West Midlands Interchange Proposed Non-Material Change Environmental Implications Report

West Midlands Rail Freight Interchange Order 2020 (as amended).

Four Ashes Limited
June 2023

Figure 3.7: Proposed Development Zone Parameter Extent - Zone C Northern Extent

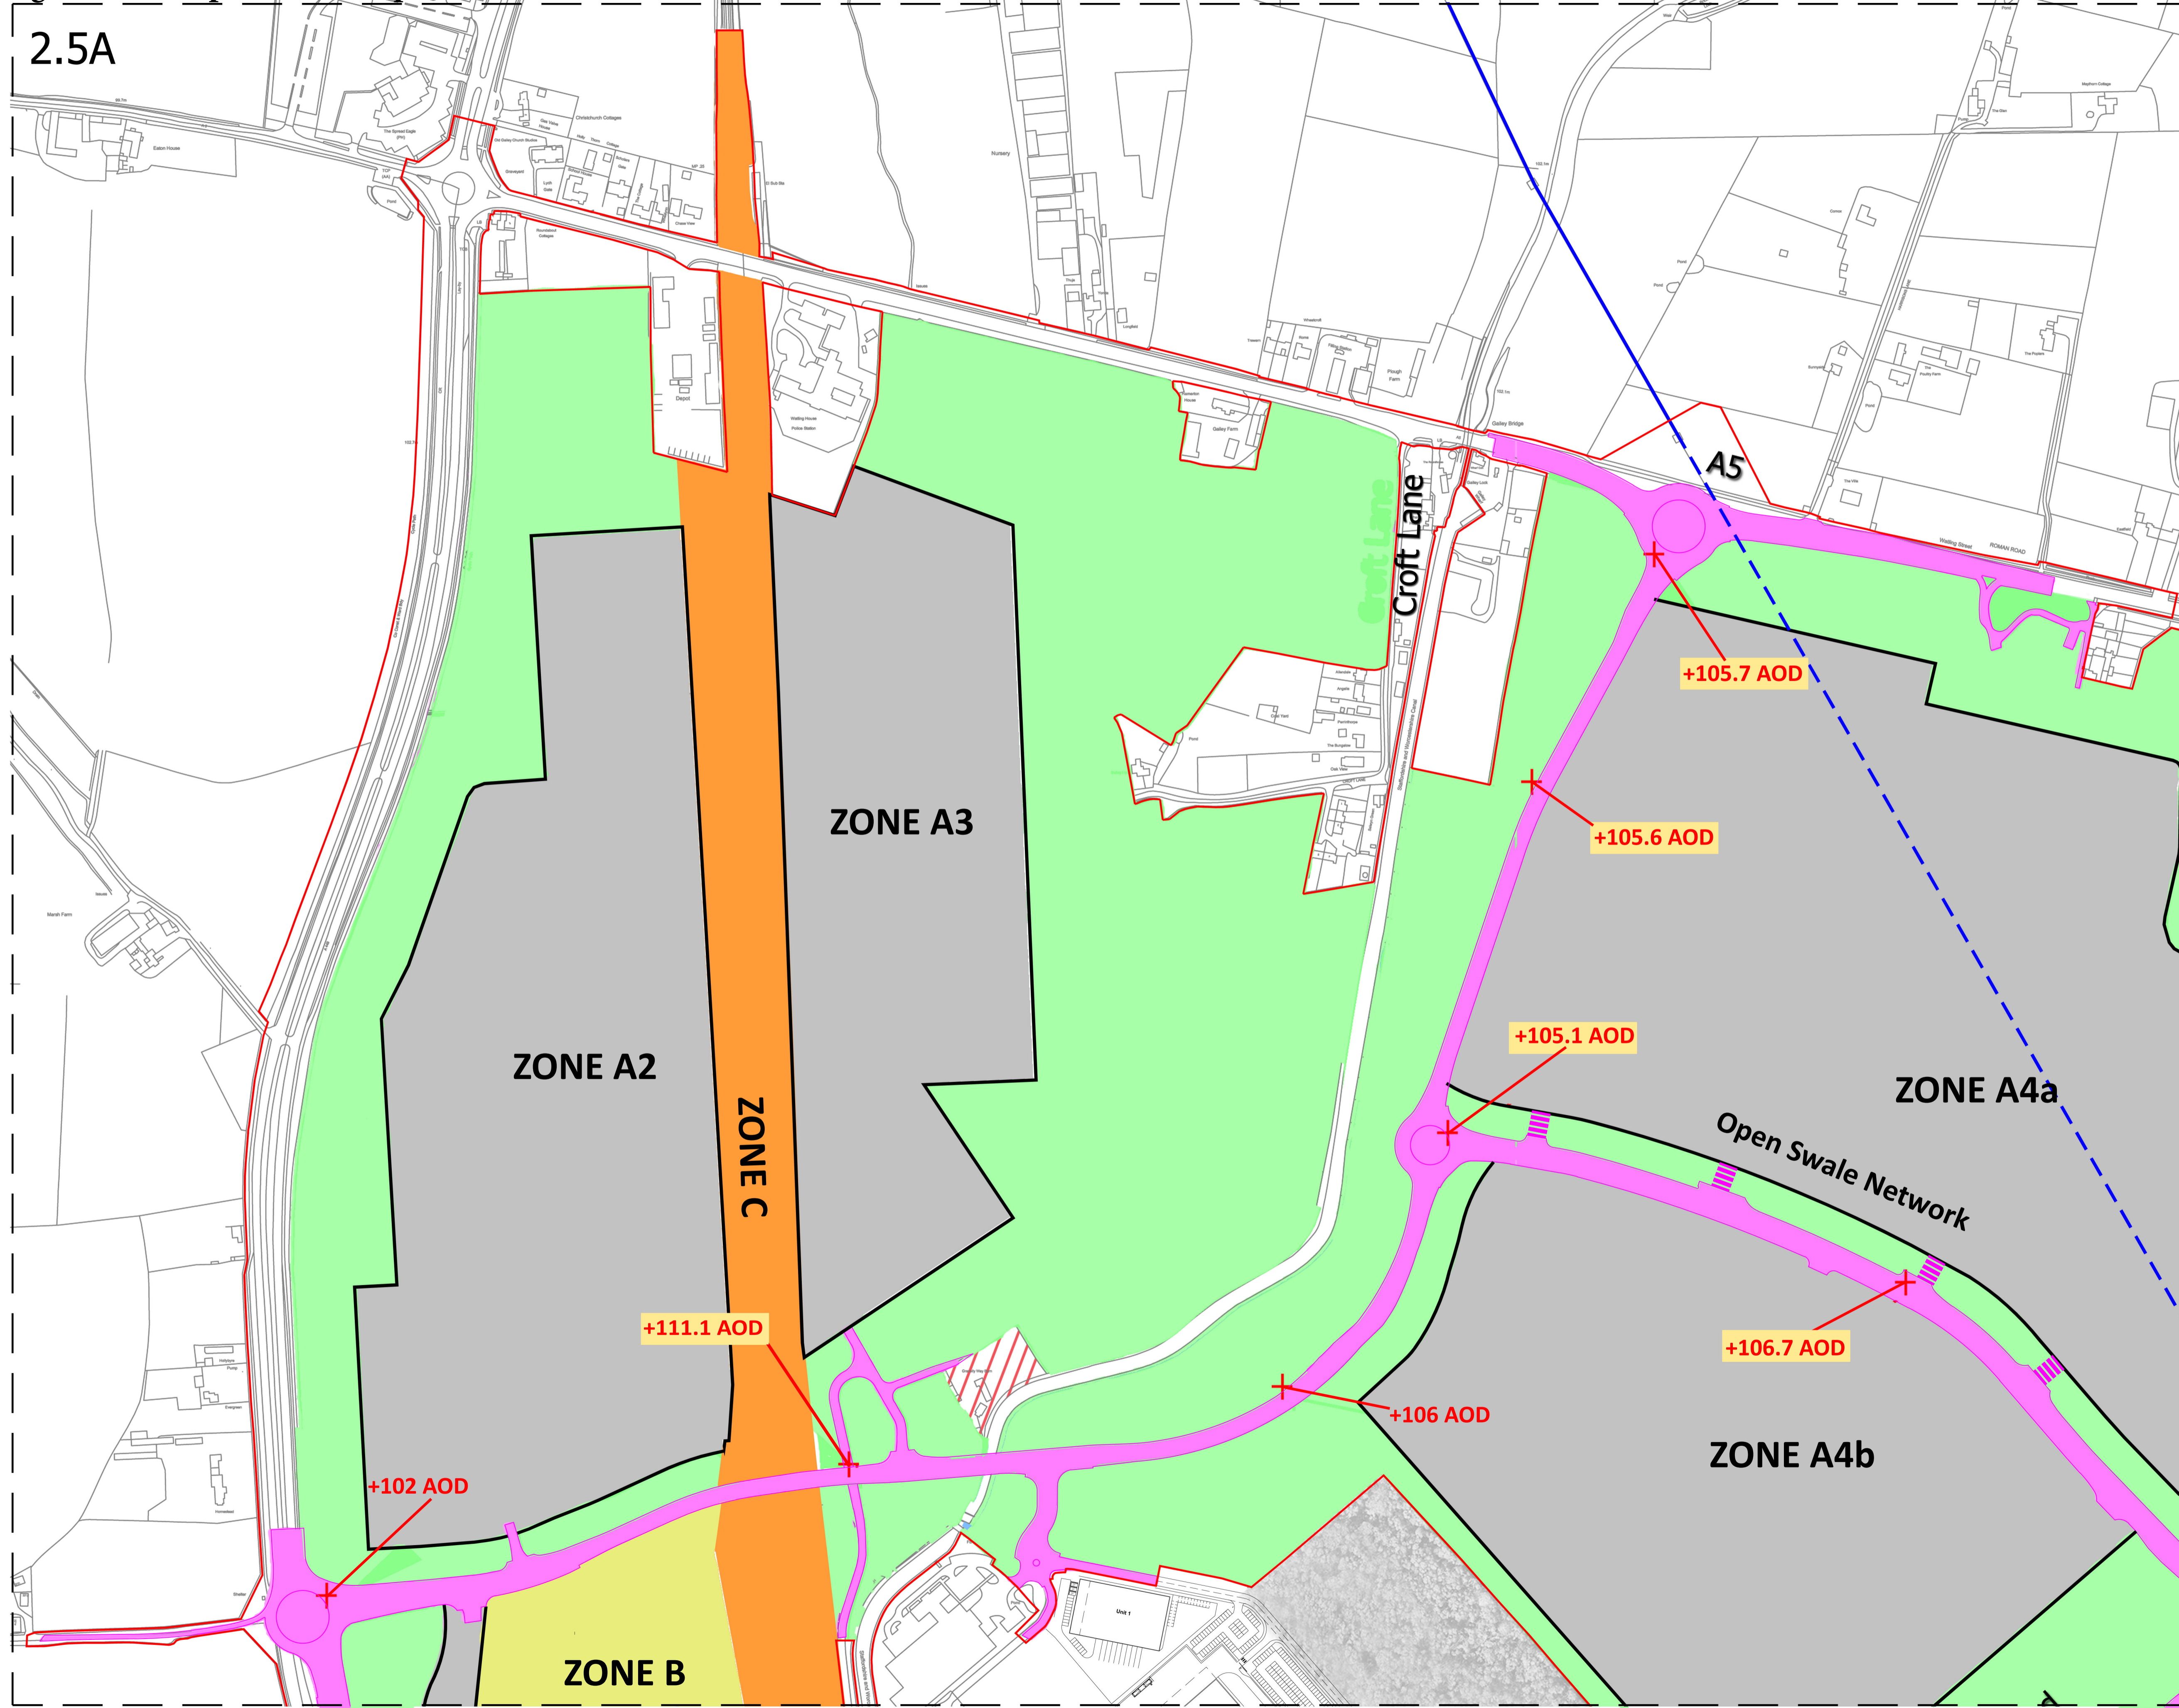
The proposed amendment seeks to incorporate an additional 0.129 ha of land into Zone C (railway works) , as shown in **Figure 3.7, Appendix A**, to facilitate the proposed change to double-tracking under Bridge No.1 (see Section 3.2.3). This would result in a net reduction in area for Landscaping by 0.0347 ha, for Rail Freight Infrastructure by 0.0418 ha, for highways infrastructure by 0.0172 ha, and for Rail Served Warehousing by 0.0192 ha. This reduction in Rail Served Warehousing area does not affect the ability to deliver the maximum quantum of floorspace identified on the certified Development Zone Parameters Plan.

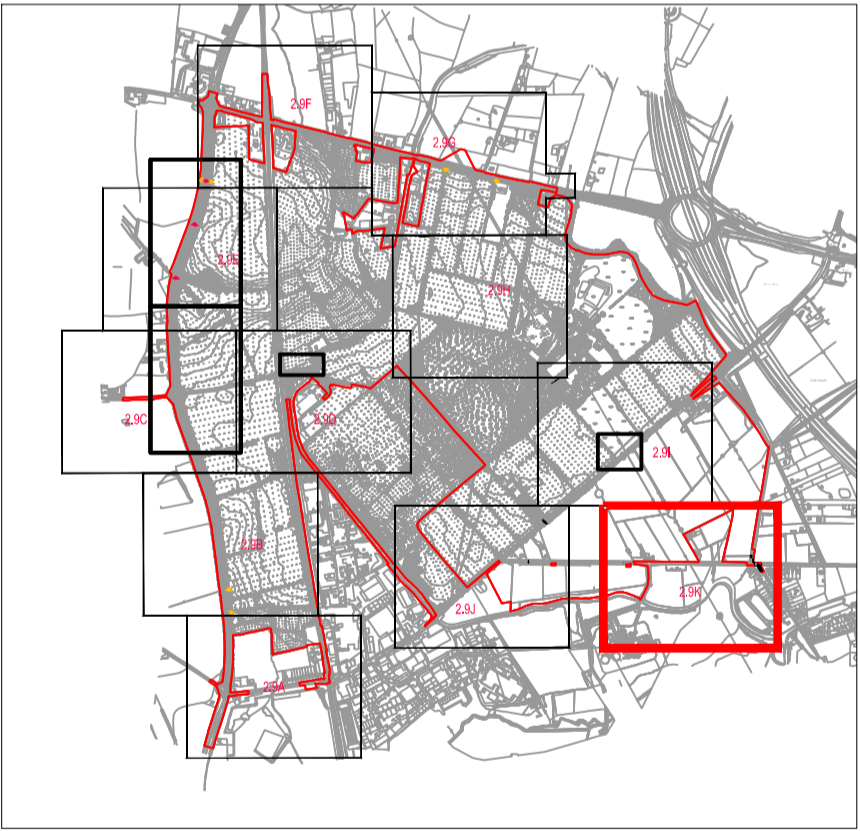
The new dropped kerb crossing on Straight Mile is proposed to be shifted 15m westward, as shown in **Figure 3.8, Appendix A**.

Owing to the constraint posed by a drainage ditch running along western edge of Woodlands Lane, the new dropped kerb crossing would be formed on eastern side of Woodlands Lane, allowing crossing from proposed Calf Heath Community Park, leading to a new footway along the eastern side of Woodlands Lane down to Straight Mile, where a dropped kerb crossing would allow pedestrians to cross to the new footway on Kings Road. This would remove the need for 35m of footway on the southern side of Straight Mile.
